Product / Process Change Notification (PCN)

PCN #: PCN_IndTIF_20201107
Affected Series: WE-TIF
 7447211xxx, 7447221xxx, 7447231xxx

PCN Date: August 07, 2020
Effective Date: November 07, 2020

Marking with pad-printing

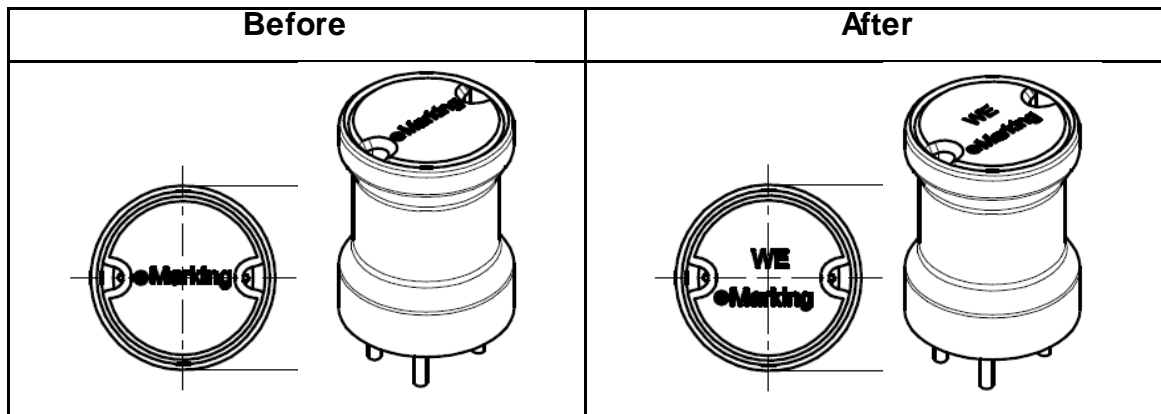
- All electrical and mechanical properties of the parts will remain the same.
- Pad-, inkjet- and laser-printing will be used from now on.
- Printing method can be identified on the label by the 13th digit in the lot number.

Lot.-No. for pad-printing: xxxxxxxxxxxx0xx
 Lot.-No. for inkjet-printing: xxxxxxxxxxxx1xx
 Lot.-No. for laser-printing: xxxxxxxxxxxx2xx
